Authors' response

3. Authors' Response to reviewers RC1 and RC2 of manuscript

JLH Mark2 - An Improved Opto-Mechanical Approach to Open-Path *in situ* Water Vapor Measurement in the Upper Troposphere / Lower Stratosphere

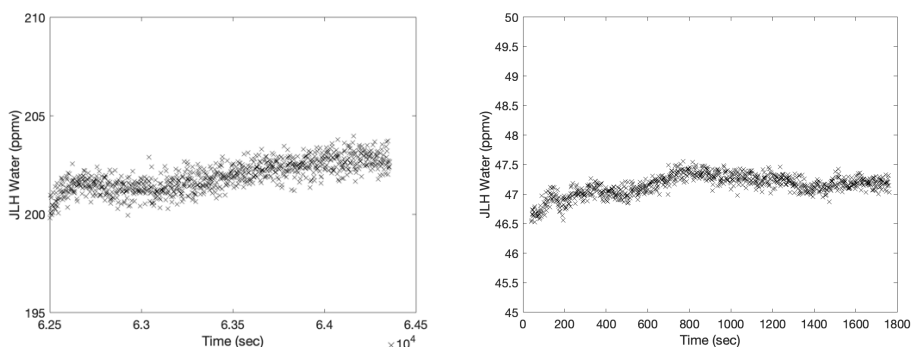
7. Line 577-588: The AIDA chamber demonstrations are an important "necessary" condition for the water vapor sensors that participated, meaning that one would expect the instruments to agree to within their stated uncertainties. In this case, you report "within 10% over a wide range of temperatures" which seems to be considerably larger than a back-of-envelope estimate of errors you note of 1% to 2% of various components of your careful analysis when added in quadrature. Because the JLH family of instruments are so critical to our understanding of stratospheric water, representing the only near-continuous record of in situ observations from aircraft spanning over three decades, it seems to me this paper is an excellent opportunity to "plant the flag" and make definitive statements about your best estimate for true uncertainty in the measurements without worrying about other methods which are much more difficult to "prove" from first principles. Although not required for this paper to be publishable, I think you should expand on this section, if only a little, – perhaps ½ to 1 page – to provide your best "sense" of what the true uncertainties in the water vapor mixing ratios are when the instrument is working properly. Hopefully at some point you will have a more rigorous analysis of uncertainties, as this would be a very useful addition to the literature and historical record for JLH. Until then, would it be possible to make a summary statement about the largest sources of error in the JLH measurements and what they add up to in terms of accuracy over a typical range of pressures and temperatures for your flights?

In Section 2.3.2 (see below), we will provide a summary statement about the largest sources of error in the JLH measurements and what they add up to in terms of accuracy

“Below, we describe a recent example of JLH laboratory calibration. Fig. 4a and 4b show time series of JLH measurements within the lab calibration chamber as 200 ppmv and 50 ppmv, respectively, are flowed through the chamber.
